NOTICE OF DECISION

CLASS 3 SITE PLAN REVIEW / CLASS 1 ADJUSTMENT
CASE NO.: SPR-ADJ22-53

SUMMARY: Proposed new Panda Express restaurant with drive-through and associated site improvements.

IN THE MATTER OF APPROVAL OF) FINDINGS & ORDER
CLASS 3 SITE PLAN REVIEW & CLASS 1)
ADJUSTMENT CASE NO. SPR-ADJ22-53;)
1292 LANCASTER DRIVE NE) JANUARY 24, 2023

ARCHITECTURAL SITE PLAN 1

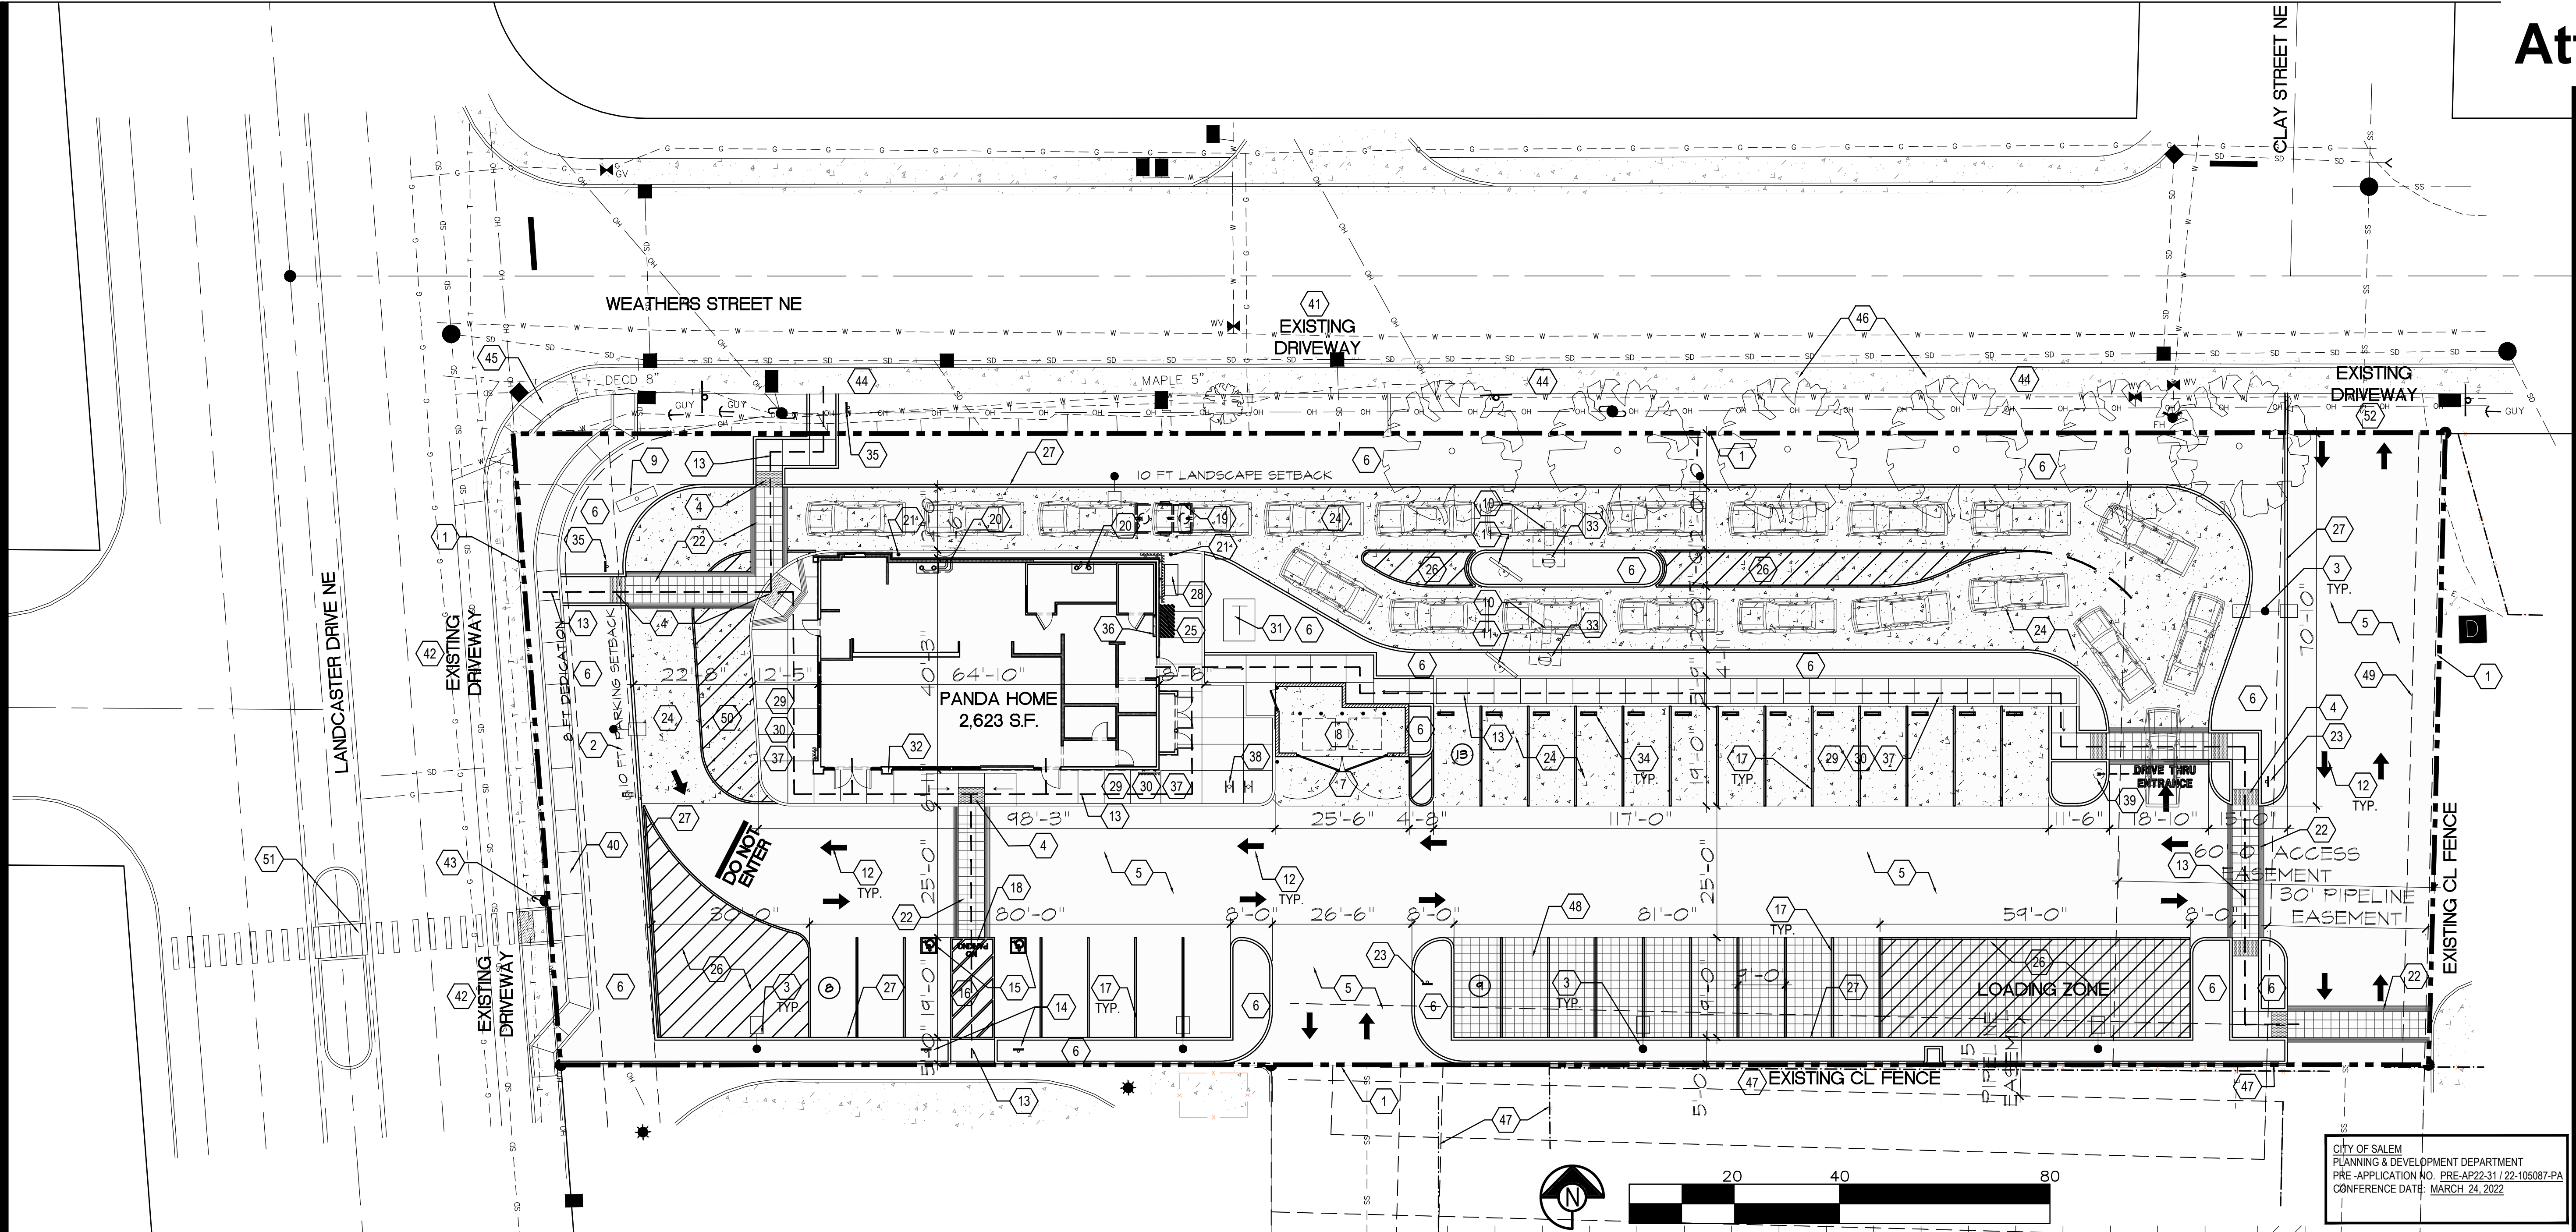
Staff Response: As shown on the site plan, an electrical transformer is proposed to be located to the east of the proposed building in the area generally north of the proposed trash enclosure and south of the proposed drive-through lanes. As indicated in the comments from PGE, the proposed transformer location does not meet their utility infrastructure siting standards. In order to ensure the proposed electrical transformer is located in an area of the site that meets PGE requirements the following condition of approval shall apply:

As shown on the site plan, the proposed restaurant is located adjacent to a parking lot and a drive-through lane which wraps around the building. A minimum 5-foot setback is not required between the drive-through lane and the building, and a paved sidewalk more than 5 feet in width is provided around the building to the west,

The proposed development includes one trash enclosure/collection area meeting the definition of a solid waste service area under SRC 800.010. As shown on the applicant’s site plan, the trash collection area is enclosed by a 7-foot 4-inch-tall wall, has an interior dimension within the enclosure of approximately 24 feet in width by 8.67 feet to 12.67 feet in depth, and includes an unobstructed vehicle operation area that is approximately 16 feet in width by 45 feet in length.

As shown on the applicant's site plan, the subject property is a corner lot with frontage on both Lancaster Drive NE and Weathers Street NE. In order to meet the pedestrian access requirements of SRC 800.065(a)(1)(A), a pedestrian connection is provided from the primary entrance of the building to both Lancaster Drive and Weathers Street. The pedestrian access requirements of SRC 800.065(a)(1)(B) are not applicable to the proposed development because although Lancaster Drive includes a transit route (*Cherriots Route 11: Lancaster/Verda*), there is no existing or planned transit along the frontage of the property.

As shown on the site plan, vehicular access to the proposed development will be provided via two shared driveways that are approximately 28.5 feet and 26.5 feet in width. The proposed development conforms to this standard.

As shown on the applicant's site plan, the proposed development includes a driveway which extends to the southern boundary of the property to provide access to Lancaster Drive through the abutting property to the south. As indicated in the written materials provided from the applicant, access rights through the abutting property to the south to accommodate the proposed shared access to Lancaster Drive NE are being developed between the applicant and adjacent property owners. In order to ensure the proposed development will have access rights to Lancaster Drive NE through the abutting property to the south, the following condition of approval shall apply:

- Condition 1:** The proposed pad-mounted transformer shall be located within 10 feet of a vehicle access surface in conformance with PGE standards.
- Condition 2:** The proposed off-street parking shall be revised to provide a minimum five percent interior landscaping.
- Condition 3:** A minimum of three trees within the proposed off-street parking area shall be deciduous trees of a species that meets the definition of shade tree under SRC 807.005.
- Condition 4:** The parking area landscape island located immediately to the east of the proposed trash enclosure area shall have a minimum width of five feet.
- Condition 5:** The trash/recycling area shall conform to the solid waste service area standards of SRC 800.055.

Condition 2: The proposed off-street parking shall be revised to provide a minimum five percent interior landscaping.

LANDSCAPE PLAN

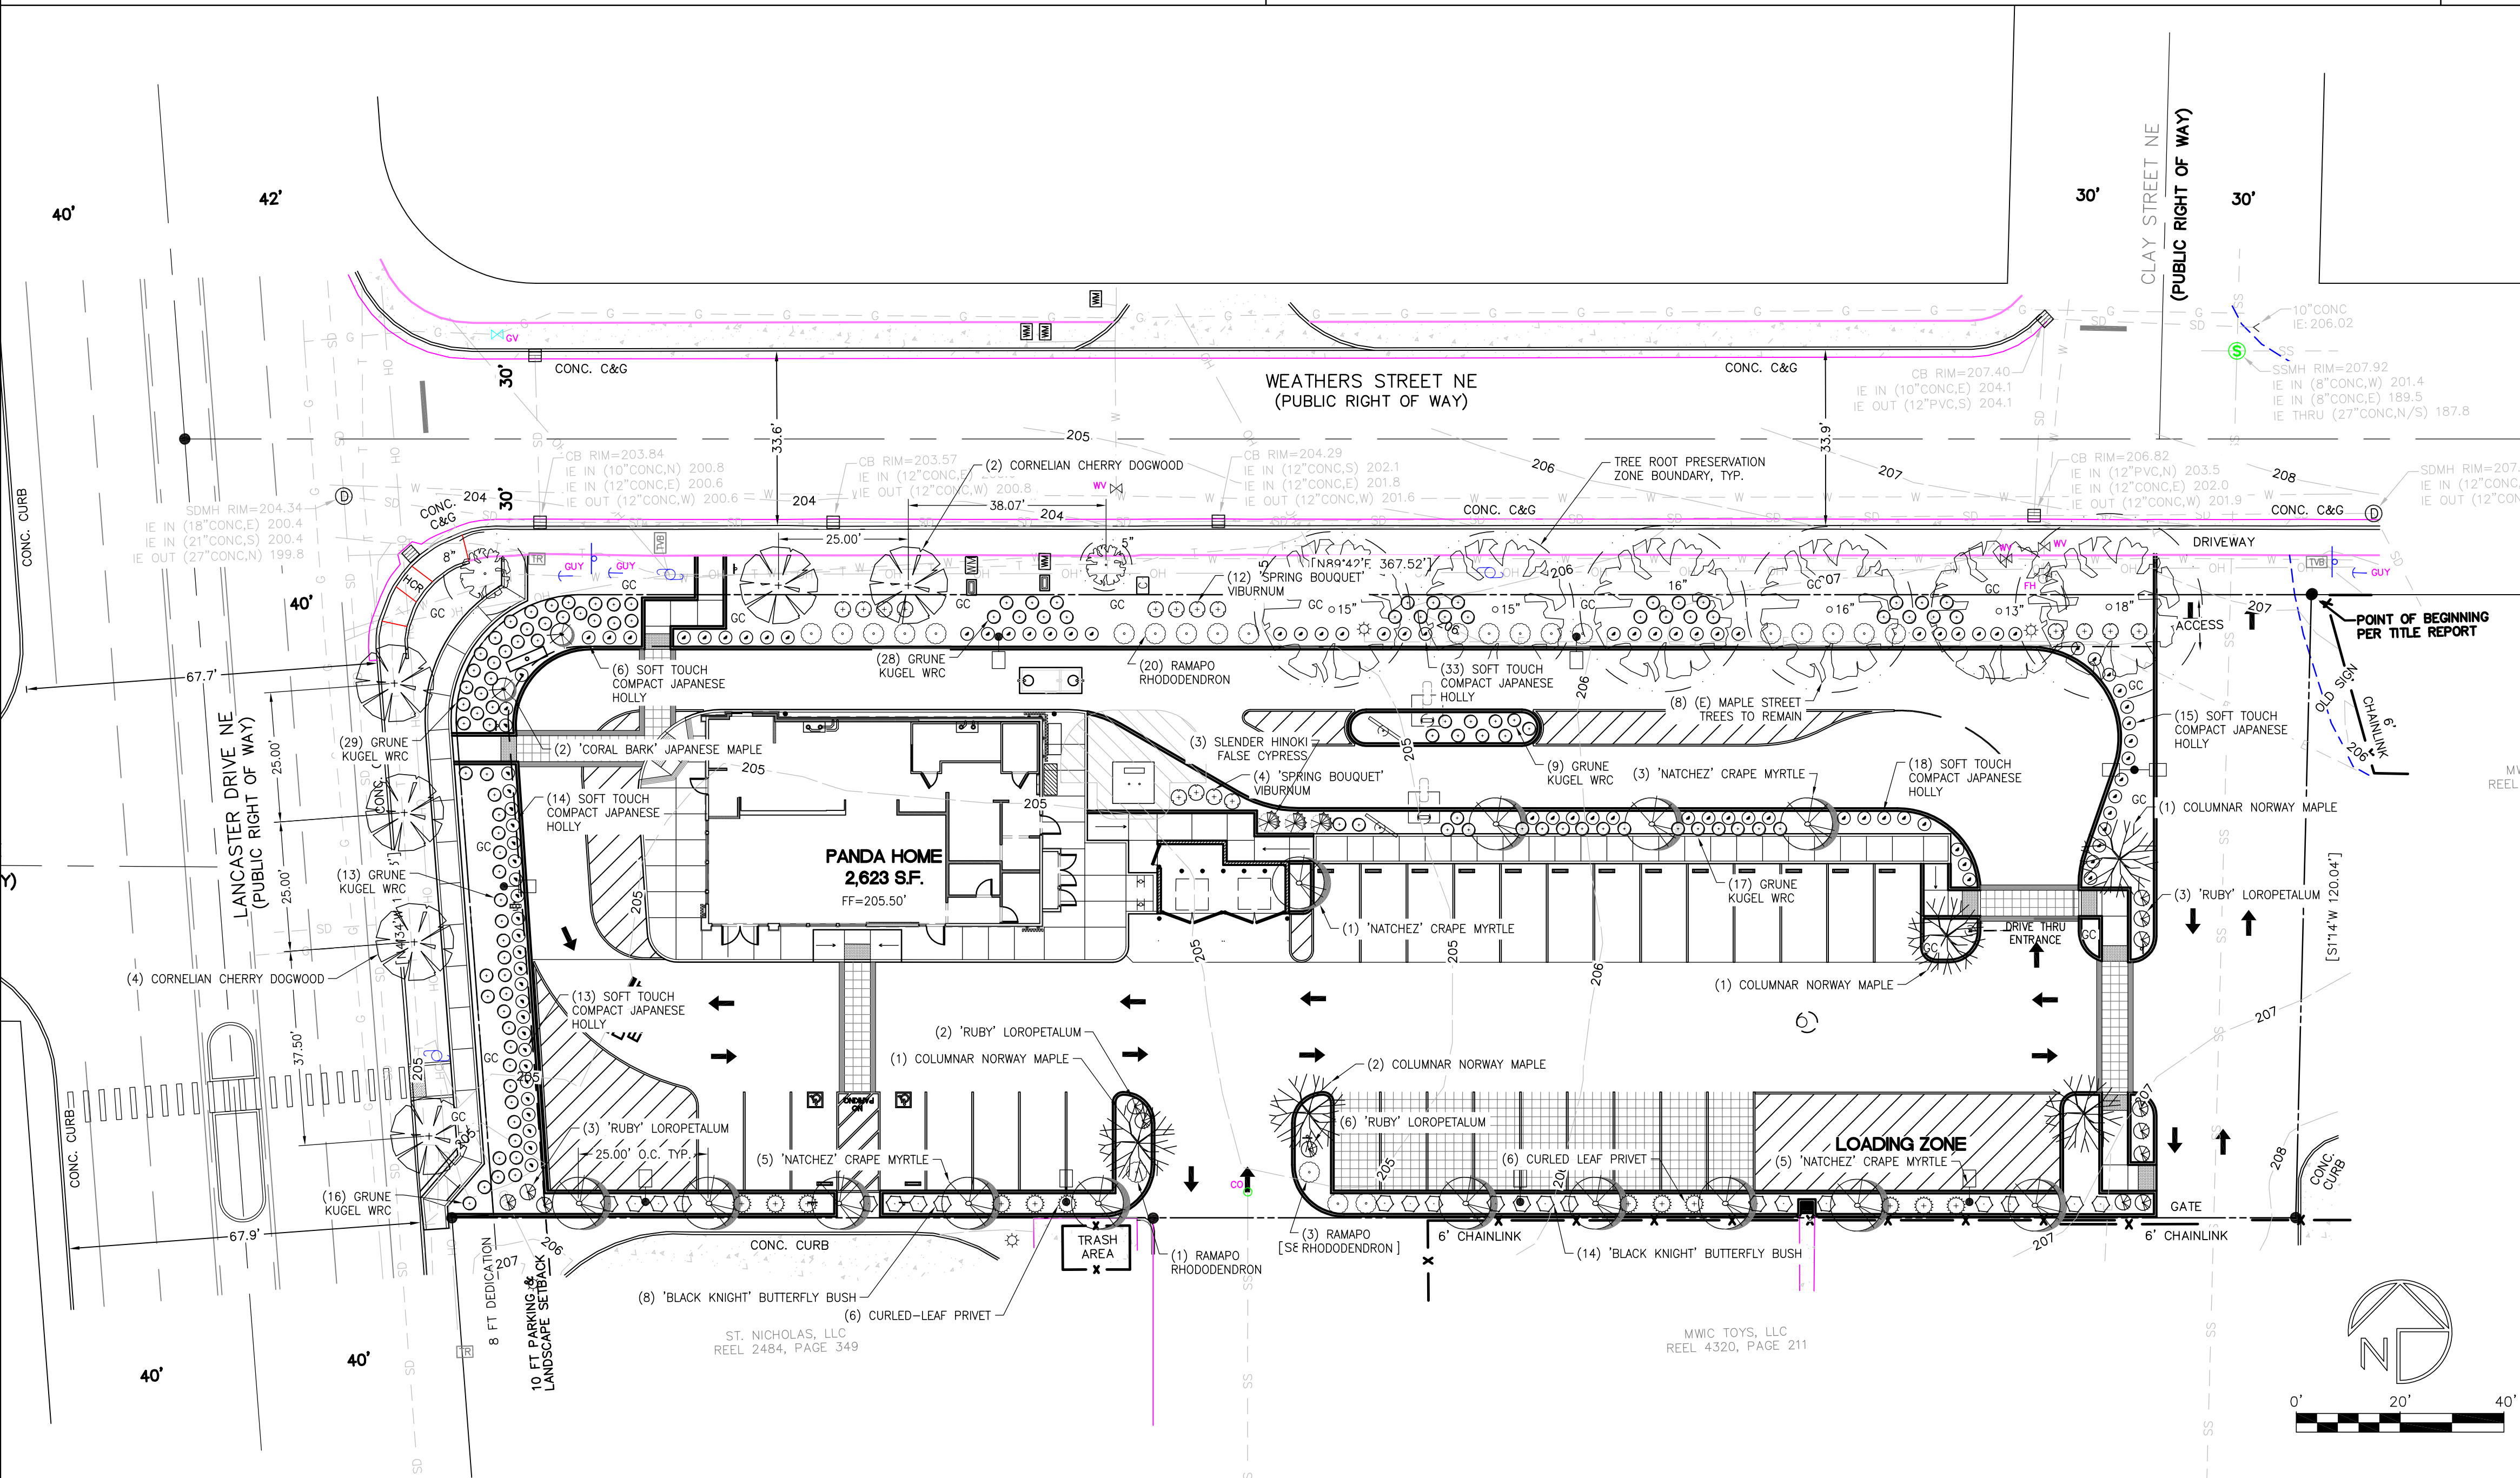
As shown on the applicant's landscape plan, a total of approximately 629 square feet of interior parking lot landscaping is provided which does not conform to the

Based on the 30 off-street parking spaces proposed, a minimum of three deciduous shade trees are required. As shown on the applicant's landscape plan, a total of five trees (*four columnar Norway maples and one Natchez crape myrtle*) are proposed within the off-street parking area. While the number of trees provided exceeds the minimum number of trees required, the tree species identified are not shade trees because they are columnar and/or do not possess a high crown of foliage or overhead canopy. In order to ensure that the interior parking lot landscaping requirements of SRC 806.035(d)(3) are met, the following condition of approval shall apply:

SRC 806.035(d)(4) requires landscape islands and planter bays within off-street parking areas to be a minimum of 25 square feet in size with a minimum width of five feet. As shown on the applicant's landscape plan, a total of six parking area landscape islands are provided that all conform to the minimum size and dimension requirements with the exception of the landscape island located immediately to the east of the proposed trash enclosure area. While this landscape island conforms to the minimum size requirement, it does not meet the minimum required 5-foot width. In order to ensure that all landscape islands included within the parking lot conform to the size and dimension requirements of SRC 806.035(d)(4), the following condition of approval shall apply:

Development Site Landscaping. The subject property is approximately 0.99 acres in size and therefore a minimum of 6,469 square feet of the development site is required to be landscaped. As shown on the applicant's landscape plan, a total of approximately 7,142 square feet (*16.6 percent*) of the development site is landscaped. The proposal therefore conforms to the development site landscaping requirements of SRC 522.010(d)(3).

As shown on the applicant's site plan and landscape plan, there are six existing trees on the property located in the northeast portion of the site adjacent to the Weathers Street NE right-of-way. The *dbh* of these trees range from 15 inches 18 inches and none of the trees are significant trees. As shown on the site plan and landscape plan, these trees are proposed to be retained. The proposed development conforms to the requirements of SRC Chapter 808.
